CABINET MEMBER FOR ENVIRONMENT – 27 FEBRUARY 2014

AMENDMENTS TO PROPOSED RESIDENTS PARKING SCHEME CUTTESLOWE AREA, OXFORD

Report by Deputy Director for Environment & Economy (Commercial)

DRAWING TITLE
**REVISED PROPOSALS
WEST SIDE**

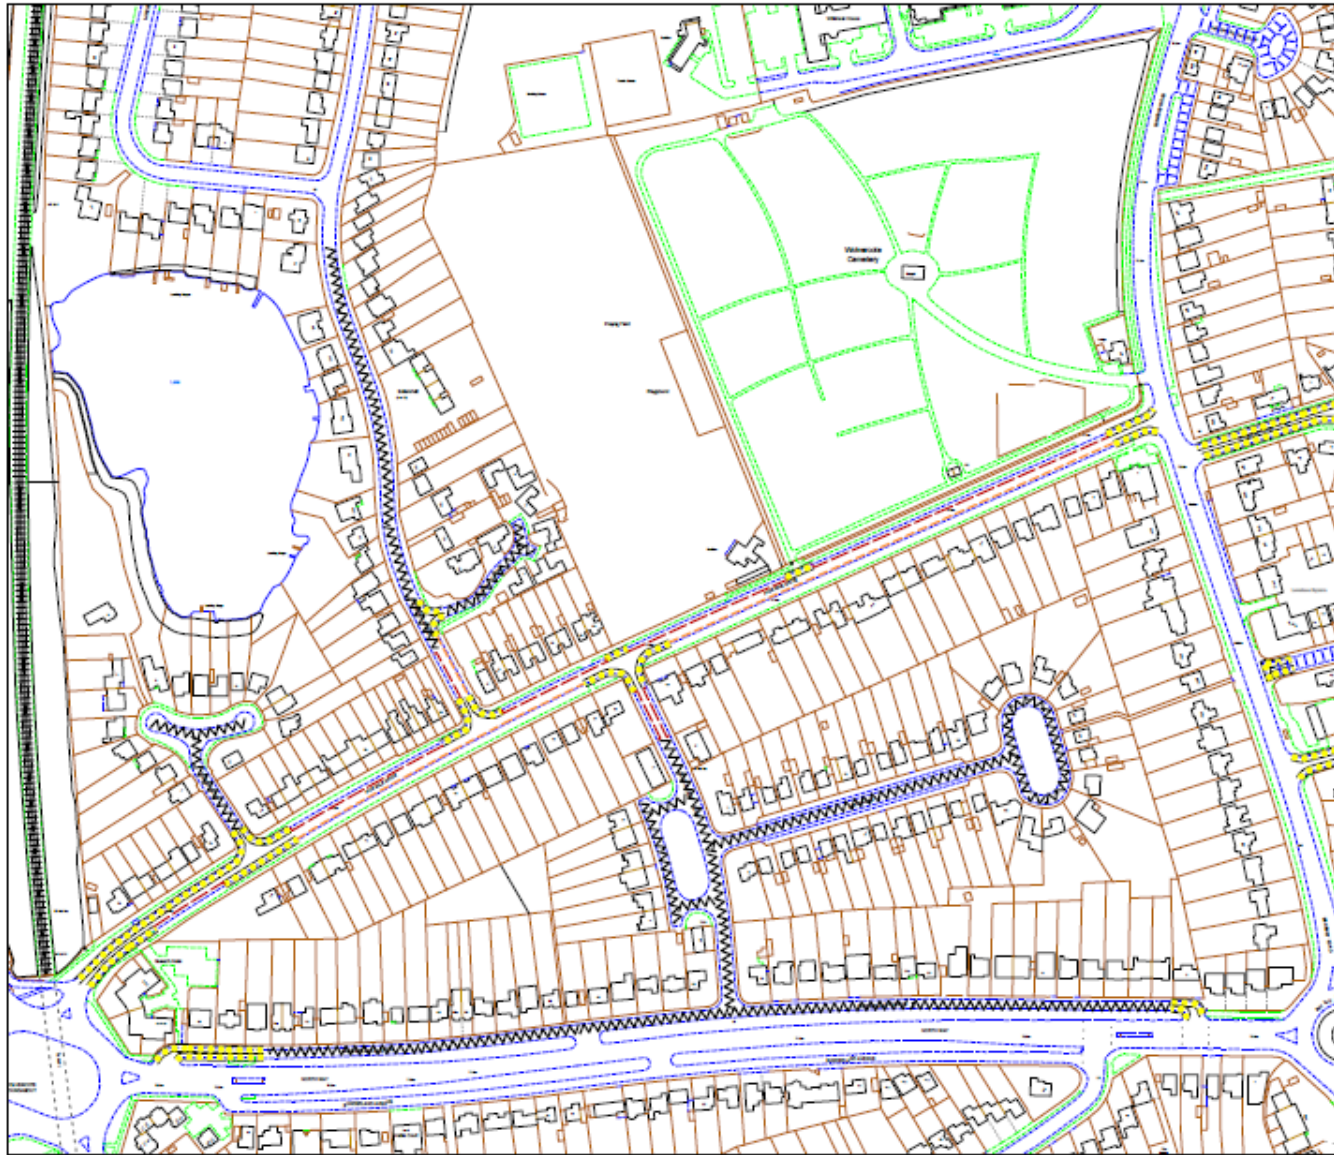
RESPONDENT	COMMENT	OFFICER RESPONSE
Petition from 46 residents of Linkside Avenue (some have also responded separately)	<p>Are of the opinion that the whole of Linkside Avenue should be included in the CPZ and the proposals should be amended accordingly.</p> <p>Believe that having only part of the Avenue in the scheme will encourage drivers to park unchecked in the other sections of the Avenue to the detriment of residents who may well find access to property impeded.</p> <p>Urgently request that the County Council considers the above and amends the proposals accordingly.</p>	Following comments made in response to this consultation it is now proposed that the whole of Linkside Avenue is included in the CPZ.
Two residents, Linkside Avenue	<p>Recommends that the restrictions be extended to the full length of Linkside Avenue as was proposed by many residents at the October meeting. The reason was explained that many of those parking in the area are people with cycles in the boot of their cars and cycling on to their destination. By finishing the restrictions at No 17 this will just push the parking further down Linkside, as cycling a few yards down the road will mean nothing to those people.</p> <p>It is already apparent that the Five Mile Drive area has shown an increased volume of all day parking since the Water Eaton Park and Ride has been made a paying facility.</p>	Following comments made in response to this consultation it is now proposed that the whole of Linkside Avenue is included in the CPZ.

Resident, Linkside Avenue	<p>Pleads to extend the scheme to the northern end of Linkside Avenue (beyond Lakeside), otherwise commuters (with bicycles) debarred from the southern end and Five Mile Drive will take themselves up here. Gather that a handful of neighbours voted against this last time round (perhaps because of the permit fees). Some voted in favour. The majority will not have responded at all - as is usually the case in these situations — but will be up in arms once the cars park outside their houses.</p>	Following comments made in response to this consultation it is now proposed that the whole of Linkside Avenue is included in the CPZ.
Two residents, Linkside Avenue	<p>Would wish that the restrictions should be applied to whole of Linkside Avenue for the following reasons:</p> <ul style="list-style-type: none"> • Since parking charges have come into force at Water Eaton Park and Ride, the whole of Five Mile Drive, together with Rotha Field Road has become totally congested with parked cars during working hours. 	Following comments made in response to this consultation it is now proposed that the whole of Linkside Avenue is included in the CPZ.

<p>Resident, Linkside Avenue</p>	<p>Clear support for the extension of the scheme to include the entirety of Linkside Avenue and Lakeside.</p> <p>As a daily cycle commuter I'm very aware of the large number of people who park in the areas around Linkside and travel the remainder of their journey by bike. If they have made the commitment - whether for financial or health reasons - to commute in this way then an extra few hundred metres (around 30 seconds' travel time) will not deter them from using any available parking space.</p> <p>Having experienced the benefits of the permit scheme at a previous address, it seems nonsensical to allow a small area of permit-free parking spaces to be taken up by eager-eyed commuters. The cost of a permit would be a small price to pay to avoid the remaining few parts of Linkside/Lakeside becoming a daytime car park.</p>	<p>Following comments made in response to this consultation it is now proposed that the whole of Linkside Avenue is included in the CPZ.</p>

Resident, Linkside Avenue	<p>Feels that the proposed scheme for Linkside Avenue would be highly inconvenient for people living and visiting Linkside Avenue. Thinks that Linkside should have the same parking restrictions as Five Mile Drive where the proposed parking restriction is parking limited to a maximum of 2 hours (permit holders exempt) Mon-Fri 10am-3pm. The current proposal for permit holders parking Mon-Fri 10am-3pm would cause a lot of inconvenience for the many visitors arising from having three small children and have frequent short visits from other parents dropping children off or picking up children, etc. Using the visitors permits for these types of visits would be impracticable and would use up our visitors permits quickly.</p> <p>The residents parking scheme for our area was proposed to stop people parking all day on residential streets. If the same parking restrictions as Five Mile Drive (parking limited to a maximum of 2 hours (permit holders exempt) Mon-Fri 10am-3pm) applied then this would solve the problem of people who don't live in the area parking all day without having a detrimental effect on the residents of Linkside Avenue.</p>	<p>The restriction previously approved was for 2-hour shared use parking throughout, but this requires specific authorisation from DfT and (as explained in the report) is no longer possible.</p> <p>One of the key desires of residents expressed at various times throughout the numerous consultations has been to have restrictions that are designed to be visually unobtrusive (by avoiding the need for parking bays etc).</p>

If Lakeside went to be excluded, so be it.	
Two residents, Linkside Avenue	Very pleased with the parking plans for Five Mile Drive and the southern part of Linkside Avenue. However, believes that when the new restrictions have been implemented, car commuters will start parking in the Northern part of Linkside Avenue. Strongly urges extending restrictions to the whole length of Linkside Avenue.	Following comments made in response to this consultation it is now proposed that the whole of Linkside Avenue is included in the CPZ.
Resident, Linkside Avenue	Request that the north side of Linkside Avenue is included in the parking scheme.	Following comments made in response to this consultation it is now proposed that the whole of Linkside Avenue is included in the CPZ.
Resident, Linkside Avenue	Expresses strong support for the inclusion of the north side of Linkside Avenue in the parking scheme.	Following comments made in response to this consultation it is now proposed that the whole of Linkside Avenue is included in the CPZ.

Two residents, Linkside Avenue	Feel very strongly that the whole of Linkside Avenue and Lakeside should be included in the proposed parking restrictions. If they are not included the pressure which these proposals are trying to resolve will be pushed into the	Following comments made in response to this consultation it is now proposed that the whole of

Two residents, Linkside Avenue	Wish our part of the street to be included in the scheme now envisaged only for the southern part of Linkside up to No 17. We feel very strongly about this.	Following comments made in response to this consultation it is now proposed that the whole of Linkside Avenue is included in the CPZ.
Resident, Linkside Avenue	Firmly in favour of residents parking in Linkside (north). Feels it would be ridiculous to stop it half way up as this will only be pushing the problems further along. There are a large number of people who park and get bikes out of their boots or people are collected by work vans.	Following comments made in response to this consultation it is now proposed that the whole of Linkside Avenue is included in the CPZ.
Two residents, Linkside Avenue	Welcome this opportunity to comment further on the proposals, as views on the scheme have changed somewhat since the original consultation a year	Following comments made in response to this consultation it is

the parking regulations to cover it as a whole.	
Resident, Linkside Avenue	<p>Would like to add voice to all those asking that the proposed parking scheme around Five Mile Drive be extended to include ALL of Linkside and Lakeside. Can't help but notice the large amounts of cyclists who park their cars and cycle the remainder of their journey; an extra hundred yards of bike travel would mean very little given what they would save in parking fees across a year.</p> <p>Fully supports the scheme's extension and feel that the annual permit charge is a very small price to pay to avoid my wonderful road becoming a daily commuter's car park.</p>	Following comments made in response to this consultation it is now proposed that the whole of Linkside Avenue is included in the CPZ.
Resident, Linkside Avenue	Lives in the northern part of Linkside Avenue in Oxford and is very concerned that this area is excluded from the scheme. Five Mile Drive and the surrounding areas become full with commuters who leave their cars and either cycle or are collected in vans and buses. If those areas are restricted to permit holders but the northern section of Linkside Avenue is not, those commuters will simply begin parking in our area. Does not want to become victims of the kind of parking and traffic congestion that have plagued Five Mile Drive. Strenuously urges the entirety of Linkside Avenue be included in the parking permit scheme.	Following comments made in response to this consultation it is now proposed that the whole of Linkside Avenue is included in the CPZ.

Resident, Linkside Avenue	Agree that there must be a parking scheme in this part of the road to avoid lots of cars in our area when they start the scheme at Five Mile Drive and the other parts.	Following comments made in response to this consultation it is now proposed that the whole of Linkside Avenue is included in the CPZ.
Resident, Lakeside	We are happy with the proposal that Lakeside is not included in any permit parking. No residents park on the road so if commuters want to park there then we are happy for them to do so.	Noted – however it is clear from the responses received that there is a strong desire from other residents that the CPZ is extended to include Lakeside.
Resident, Lakeside	Strongly supports excluding Lakeside and part of Linkside Avenue from the proposed scheme. Does not think there is at present any problem in Lakeside and considers that imposing the restrictions in Linkside and certainly in Lakeside would serve no useful purpose and is unnecessary. Considers that the commuter parking complained of is generally	Noted. However it is clear from the responses received that there is a strong desire from other residents that the CPZ is extended to include Lakeside.

<p>Resident, Lakeside</p>	<p>Thinks the road should be included in the CPZ as doesn't want a Five Mile Drive situation in Lakeside.</p>	<p>Following comments made in response to this consultation it is now proposed that Lakeside is included in the CPZ.</p>
<p>Two residents, Lakeside</p>	<p>Have noticed the increase in the number of cars parking all along Five Mile Drive, into Rotha Field Road and Linkside Avenue and have seen drivers taking folding bicycles out of their cars to continue their journeys. Are concerned that if Lakeside and half of Linkside Avenue are not included in the parking restriction scheme, it will not be long before these drivers start to park in these areas to avoid charges at the Park and Ride sites. Consequently would now like these roads to be included in the proposed scheme.</p>	<p>Following comments made in response to this consultation it is now proposed that Lakeside is included in the CPZ.</p>

Resident, Lakeside	Would like to be included in the Parking Permit scheme.	Following comments made in response to this consultation it is now proposed that Lakeside is included in the CPZ.
Resident, Lakeside	Strong support for including Lakeside and Linkside in the new CPZ being established in North Oxford, and doing so contemporaneously with this being done for Five Mile Drive and other areas north of Sunderland Avenue.	Following comments made in response to this consultation it is now proposed that Lakeside is

Resident, Lakeside	Is in agreement with proposals with two exceptions. Firstly, requests the double yellow lines on Five Mile Drive be extended to include the south side of the road opposite Linkside Avenue to assist exit from Linkside Avenue Secondly, with the increase in people cycling into Oxford from their parked cars in Five Mile Drive and Linkside Avenue believes that with the proposed scheme those vehicles will instead be parked in Lakeside unless the parking zone is extended there too. Therefore request that the Council are long sighted and extend the proposals for Linkside Avenue to include the rest of the road and Lakeside in a similar manner.	Following comments made in response to this consultation it is now proposed that Lakeside is included in the CPZ.
Two residents, Lakeside	Wants additional double yellow lines on Five Mile Drive to assist vehicles egressing Linkside Avenue and nearby on Linkside Avenue. Requests that the CPZ include the whole of Linkside Avenue and also Lakeside.	It is anticipated that the introduction of the CPZ will reduce the level of on-street parking and hence the need for additional restrictions at this location. Following comments made in response to this consultation it is now proposed that Lakeside is included in the CPZ.

<p>Two residents, Lakeside</p>	<p>Feel strongly that the proposed parking restrictions for Five Mile Drive and Linkside Avenue need to be extended to the whole of Linkside Avenue and Lakeside. See many people parking who then get bikes out of their boots or who are parking to then be collected by minibus. Feel that moving a few hundred yards down the road (to an area with no parking restrictions) will not deter them, meaning that the whole of Linkside Avenue and Lakeside could be clogged up with non-resident's parking.</p>	<p>Following comments made in response to this consultation it is now proposed that Lakeside is included in the CPZ.</p>
<p>Two residents, Lakeside</p>	<p>Strong preference for the whole of Linkside Avenue and Lakeside to have the same parking restrictions introduced as is proposed for the neighbouring roads. See no sense in excluding part of Linkside Avenue and the whole of Lakeside from the scheme; if the proposal goes ahead unchanged then the moment parking restrictions are imposed on surrounding roads indiscriminate commuter parking will simply spread to the empty space in Linkside Avenue and Lakeside. Lived in Lakeside for 30 years and over this time have observed the parking practices of those working nearby where their workspace parking provision is inadequate, those of commuters who will take any measures possible to</p>	<p>Following comments made in response to this consultation it is now proposed that Lakeside is included in the CPZ.</p>

Two residents, Lakeside,	<p>Very much in favour of proposals as have for some time had problems with parking issues in their location. Recommends that all of Linkside Avenue and Lakeside are included in the proposed New Residents Parking Permit Proposal. Believe it would benefit the neighbourhood as many working people already park all day in the area and they will simply move to the nearest convenient area to park up.</p>	<p>Following comments made in response to this consultation it is now proposed that Lakeside is included in the CPZ.</p>
Resident, Sunderland Avenue	<p>Does not want a residents parking scheme. It is not necessary, will detract from my convenience and will cause cost to the council. Would prefer the money to be spent on something else.</p> <p>Likes the fact that friends, visiting relations and tradesman can park near the house without needing to pay for a parking permit.</p> <p>Cannot see how this scheme benefits anyone, except perhaps as a way of earning revenue for the council, which is unlikely to be great as most of the houses have plenty of off road parking.</p>	<p>The proposal for including Sunderland Avenue in the CPZ was approved in 2013.</p>

<p>Two residents, ,Five Mile Drive</p>	<p>Requests that the proposed parking bay at the western end of Five Mile Drive does not proceed and the current double yellow lines remain, as these protect several property entrances and provide some deterrent against taxis waiting. States that this stretch of road is not a good one for parked cars, as there are cars queuing at rush hour times to get onto the roundabout and traffic coming off and accelerating into Five Mile Drive. It is also a school run area from the Wolvercote Primary School. Suggests that it would be a good idea to have a series of road bumps on Five Mile Drive, particularly at the Woodstock Rd end before Carey Close. It is used as a traffic cut through and will be even worse when the railway station is built at Water Eaton. The 20mph signs seem to have no effect on the speed of cut through traffic.</p>	<p>In the light of the comments received it is suggested that this parking bay does not proceed and the existing double yellow lines remain.</p>
